Planning Approval Environmental Review Form

Assessment Name:	Sydney Metro – Western Sydney Airport ER009 - Deferral and modification of precinct elements at St Marys, Orchard Hills, Luddenham and Bradfield
Prepared by:	Sydney Metro
Prepared for:	Sydney Metro and contractors
Assessment number	ER009 (SM-WSA)
Type of assessment:	EP&A Act 1979, Division 5.2. EPBC Act 1999, Part 8 and 9
Version:	Final 1.0
Planning approval No. (where relevant):	SSI_10051 Infrastructure approval (NSW) EPBC 2020/8687 (Cth)
Date required:	June 2025
iCentral number	SM-25-00027525

SM-WSA Deferral and modification of precinct elements at Orchard Hills, Luddenham and Bradfield – Pedestrian Assessment

Figure 1 Maps showing changes to lighting levels.

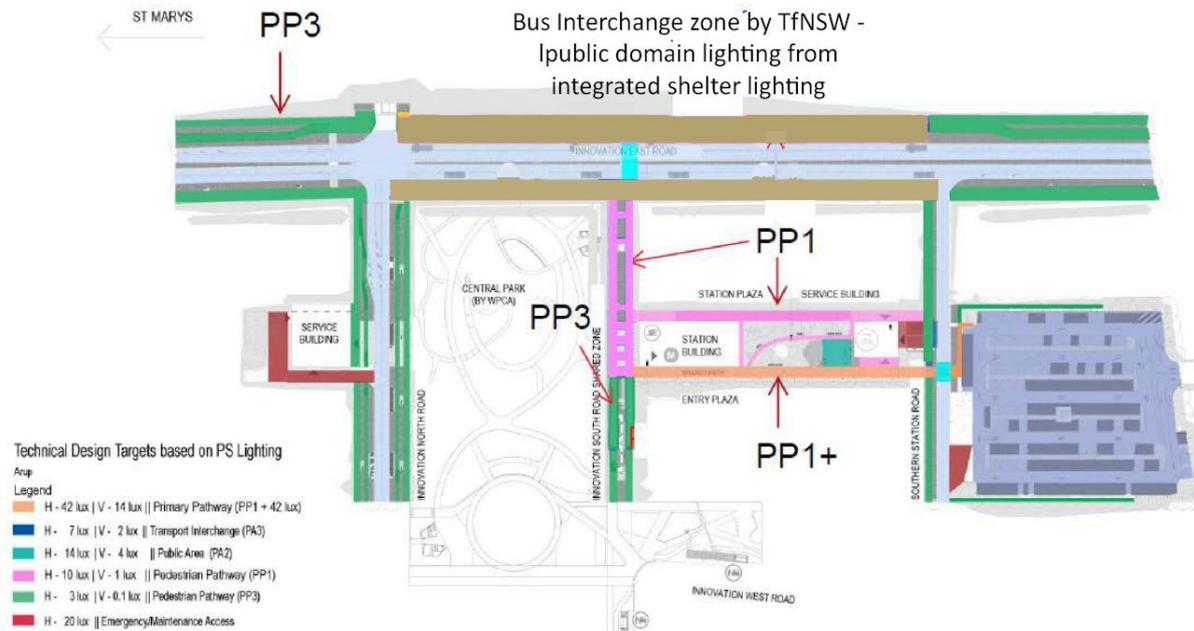
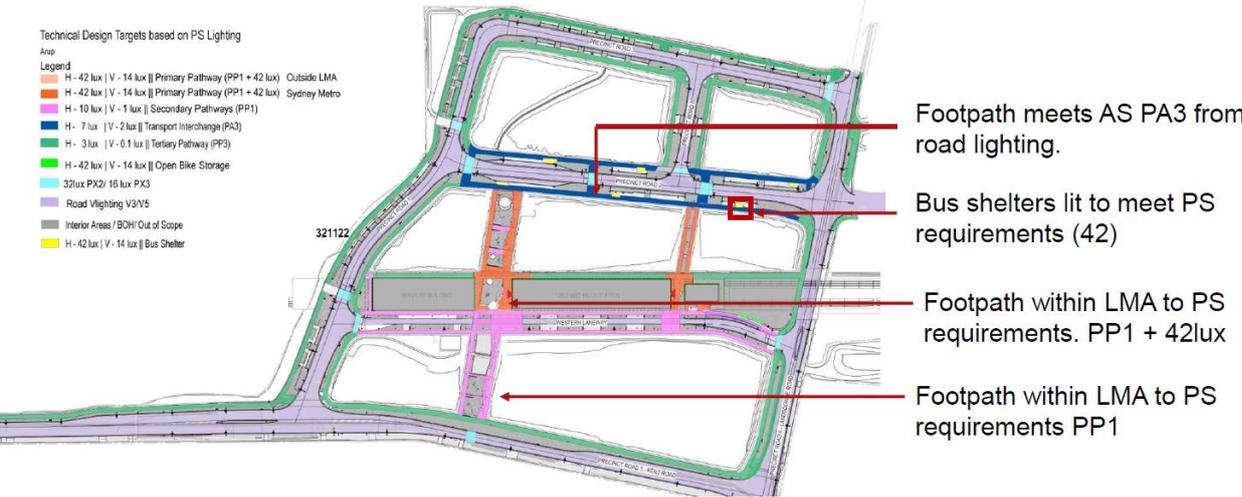
<p>emergency vehicle access to the station, and is designed as an interim arrangement until adjacent development occurs.</p> <p>Luddenham only:</p> <ul style="list-style-type: none"> • Deferral of Precinct Road 4 and relocation of kiss and ride facilities to Precinct Road 2. The design of Precinct Road 4 will be completed, including safeguarding for future delivery as part of the development of the adjoining sites but the physical works will not. • The plaza at Luddenham Station has been amended to concentrate the higher amenity landscape in the areas immediately surrounding the station building and station entries. A simplified native-seed landscape treatment is proposed for the wider station setting. <p>Bradfield only:</p> <ul style="list-style-type: none"> • Rationalisation of external footpath finishes to match the footpath finishes by the Bradfield Development Authority (BDA) on Innovation North and Innovation East (western side), change the footpath finish on Southern Station Road and Innovation East (eastern side) to plain concrete. • Reduce the footpath width on Innovation East (eastern side) from 3.5m to 1.5m, with the remaining 2m to be a grassed verge between the cycleway and footpath • Removal of public domain lighting in the bus interchange zone on Innovation East, as the existing lighting poles directly clashed with the bus interchange shelters. Lighting is instead proposed to be integrated through luminaires in the bus shelters.

Figure 2 Location of Orchard Hills precinct deferred and reduced elements

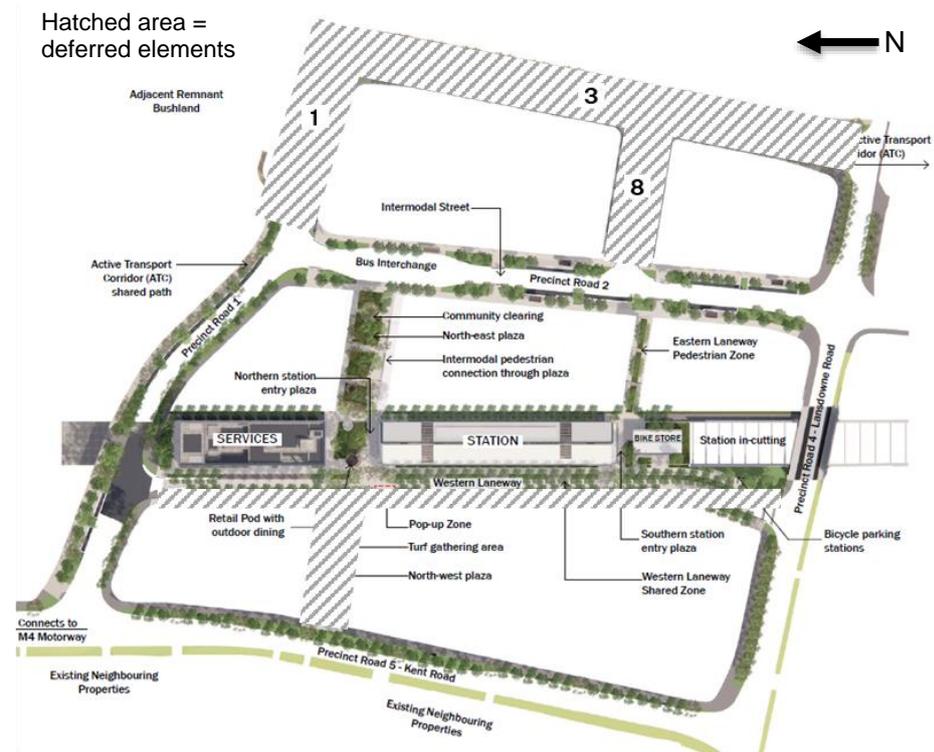
Description	Overview
Location of works	<p>The precinct elements to be deferred, or modified, are situated within the wider precinct area of Sydney Metro – Western Sydney Airport stations (off-airport stations at St Marys, Orchard Hills, Luddenham and Bradfield). The key deferred or modified scopes are shown in Figures 1 to 6.</p>
Scope of works	<p>The scope of works involves the deferral or modification of specific precinct elements indicated in the Station, System, Trains, Operations and Maintenance (SSTOM) Stage 2 Place, Urban Design and Corridor Landscape Plan (PUDCLP). The deferred elements would be delivered separate from the SM-WSA project after day 1 operations, while elements to be modified will be delivered under the same timeframe as intended. The deferred elements of this proposal do not include any physical works.</p> <p>The changes are described below and displayed in Figures 1 to 6.</p> <p>All precincts (off-airport stations):</p> <ul style="list-style-type: none"> Changes to lighting levels for: transport interchange areas (except at the New Bus Services for Western Sydney [NBSWS] Interchange Zone including adjacent footpaths and cycleways on Innovation East at Bradfield); accessible pathways to transport interchange areas; and open bike storage. This involves (1) removing secondary lighting poles at transport interchanges areas and accessible pathways to transport interchange areas and lighting these areas with road fixtures instead, and (2) reduce the lighting performance levels in accessible pathways to transport interchange areas and open bike storage areas to align with AS1158 – Lighting for Roads and Public Spaces. <p>Orchard Hills and Luddenham:</p> <ul style="list-style-type: none"> Revision of street cross sections to align with requirements by Penrith City Council, which involves the general removal of permeable pavements, tree grates, and strata vaults in the precinct streets, such as under vehicular traffic zones Removal of street furniture located outside the area maintained by the Park Life Metro (PLM) during operation of the project. <p>Orchard Hills only:</p> <ul style="list-style-type: none"> Deferral of Precinct Roads 3 and 8 and the eastern part of Precinct Road 1 (between Precinct Roads 2 and 3). The design of these roads will be completed, including safeguarding for future delivery as part of the development of the adjoining sites. Deferral of the Western Plaza (between the metro station and Kent Road). Reduced width of the Western laneway (between Precinct Road 1 and Lansdowne Road, parallel to the metro station) from 5m to 3.5m. The Western laneway would still maintain pedestrian, cyclist, operations and

Figure 2 Proposed Western Laneway Reduction

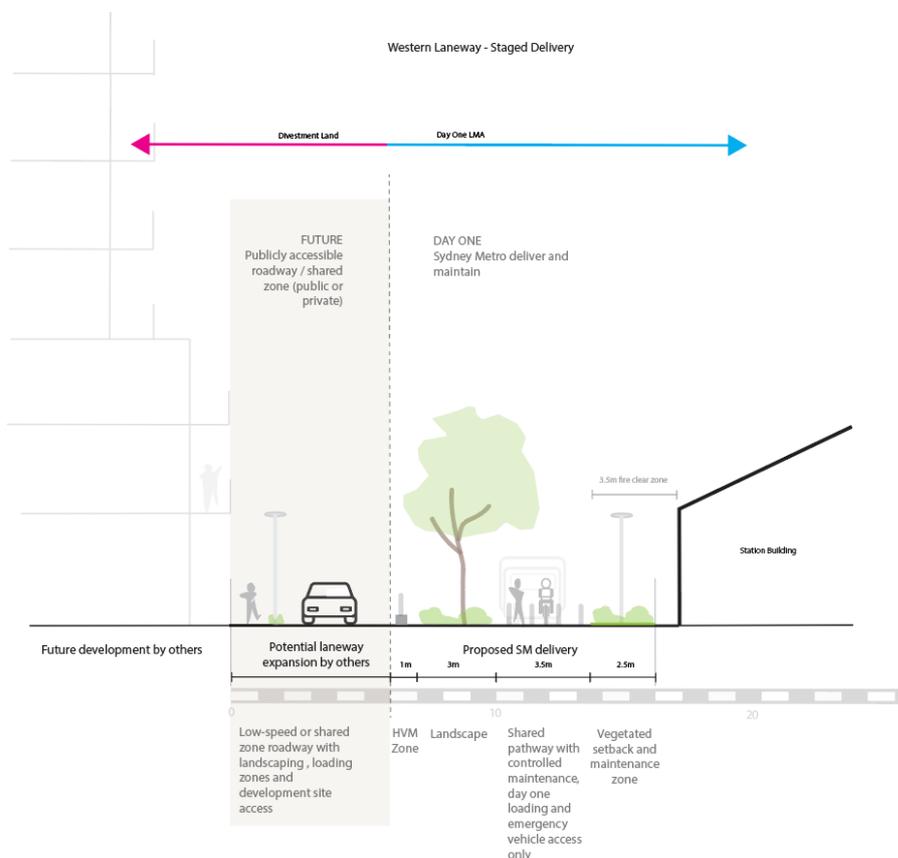
Figure 2 shows the changes to the Western Laneway. This will be reduced from 5 metres to 3.5 metres for Day 1 provision. This is a shared path so it is assumed that the full shared path width is available for pedestrians to use.

When the reduced footpath width is assessed using Fruin's LoS, the footpath still performs at LoS A in 2036 and 2056.

Figure 3 Forecast pedestrian movements at Orchard Hills in 2056
 (Source: Appendix O of SMWSASSM-PLD-OHE-SN150-CV-RPT-000002 (Figure 13))

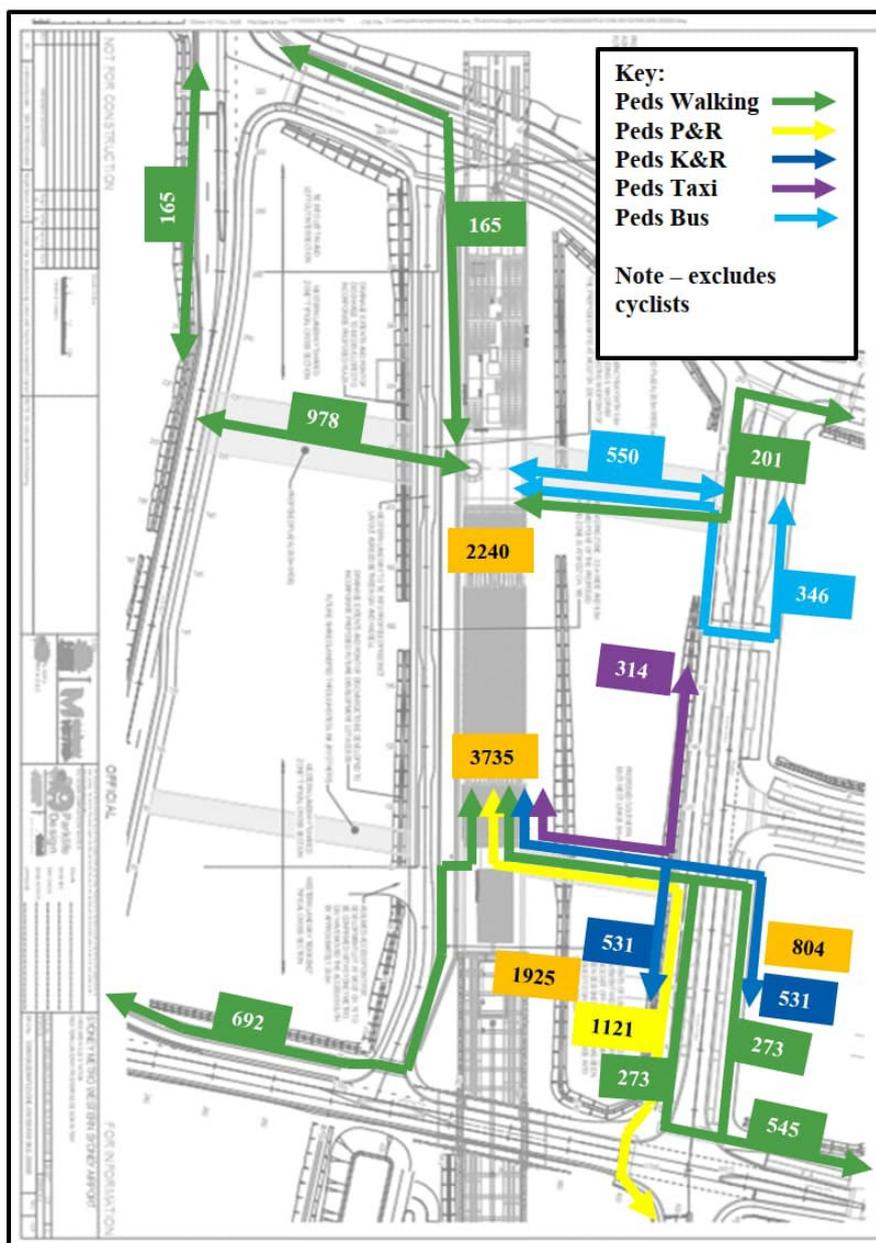
Based on Figure 3, 978 people will be rerouted from Western Plaza. This value includes the 165 people on Kent Road.

978 people were added to the forecast 165 people in Western Laneway (1,143 people total) and assessed using Fruins Level of Service based on the reduced footpath width.

Figure 4 Changes at Bradfield precinct

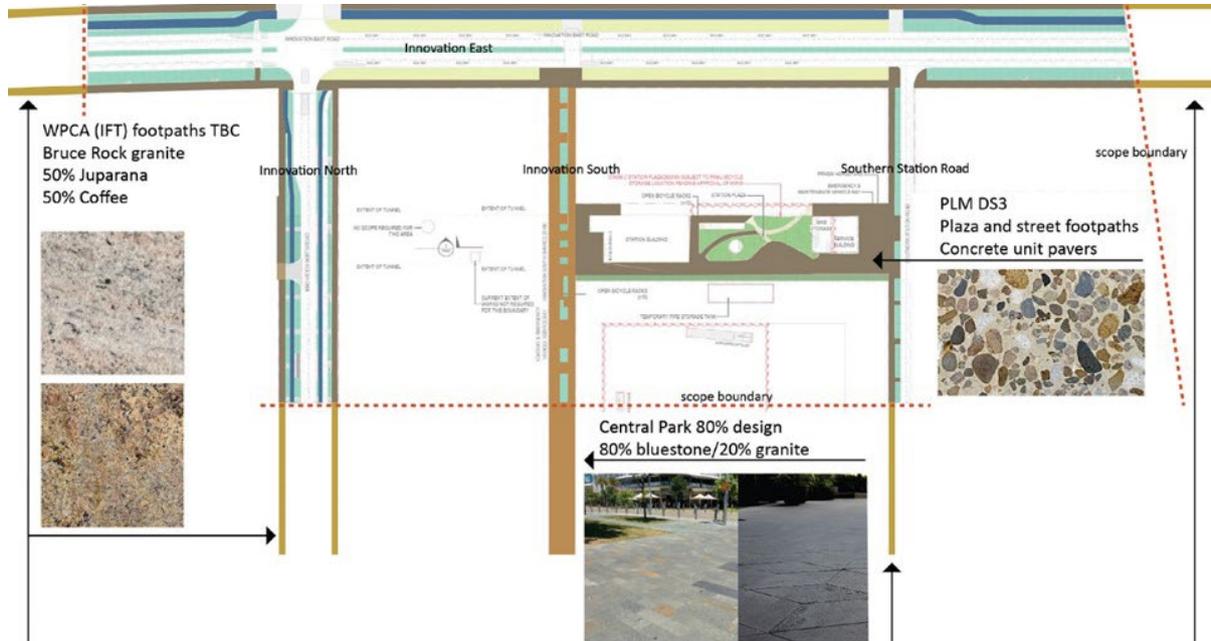
At Bradfield, the eastern footpath on Innovation East will be reduced from 3.5 metres to 1.5 metres. The precinct layout is shown below in Figure 4.

Using Fruin's LoS, a reduced footpath width still performs at LoS A in 2036 and LoS B in 2056.

Figure 5 Forecast pedestrian movements at Bradfield in 2056
(Source: Appendix G4 of SMWSASSM-PLD-AEC-SN450-RW-RPT-000001.01.S5.01.01 (Figure 13))

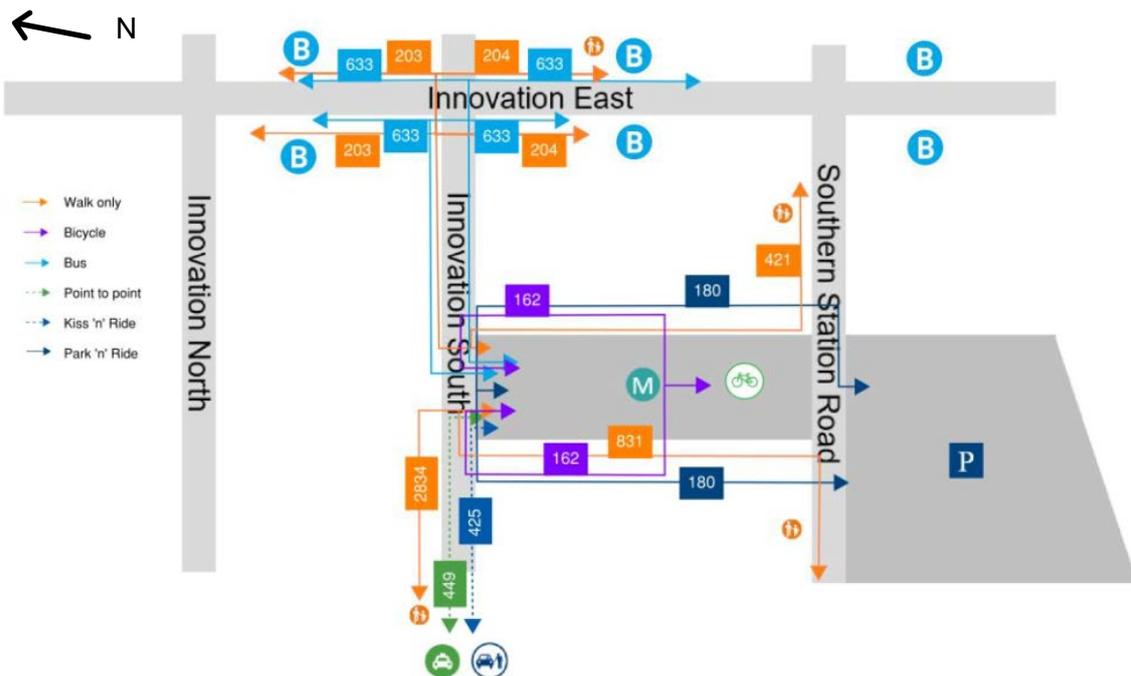
Figure 5 shows that in theory 836 people will be affected on either side of Innovation East by the reduced footpath width on the eastern side of Innovation East. In practice pedestrians are expected to use the 6m width of the bus shelter/landscaping area which offers weather protection to disperse to the north and south on the eastern side of Innovation East. This sheltered area is 6m wide so would offer a high level of service. The 1.5m footpath is temporary and will be replaced by a wider path when Stage 3 of the Bradfield City development is undertaken.

Figure 7 Changes at Luddenham precinct

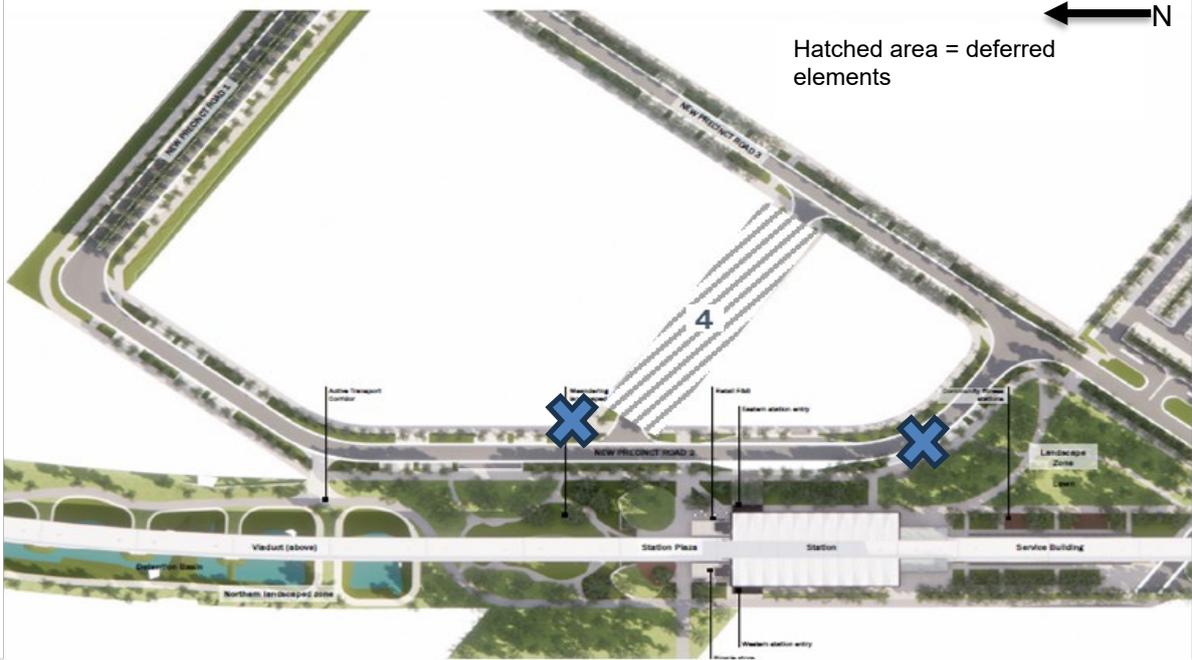
At Luddenham, the Kiss & Ride bays are being moved from Precinct Road 4 which has been deferred. The bays will be relocated to two locations on Precinct Road 2:

- The western side of Precinct Road 2, near the intersection with Precinct Road 3.
- The eastern side of Precinct Road 2, north of the intersection with Precinct Road 4.

With these Kiss & Ride changes, it is assumed that Kiss & Ride demand remains evenly split between the two locations. The 168 people associated with walking on both sides of Precinct Road 4 are assumed to be redistributed at either ends on both sides of Precinct Road 2. This adds 84 people to the analysis. This means the forecast demand changes are:

- 870 people on the eastern footpath of Precinct Road 2
- 935 on the western footpath of Precinct Road 2.

Location	Demand year	Hourly demand	Peak factor	Peak minute demand	Effective width	People per minute per metre	Fruin's LoS (walkways)
The western side of Precinct Road 2	2036 (70% of 2056 demand)	655	30% in the peak 15 minutes	13.1 people per minute	3.5 metres	3.7	A
	2056	935	30% in the peak 15 minutes	18.7 people per minute	3.5 metres	5.3	A
The eastern side of Precinct Road 2	2036 (70% of 2056 demand)	609	30% in the peak 15 minutes	12.2 people per minute	3.5 metres	3.5	A
	2056	870	30% in the peak 15 minutes	17.4 people per minute	3.5 metres	5.0	A
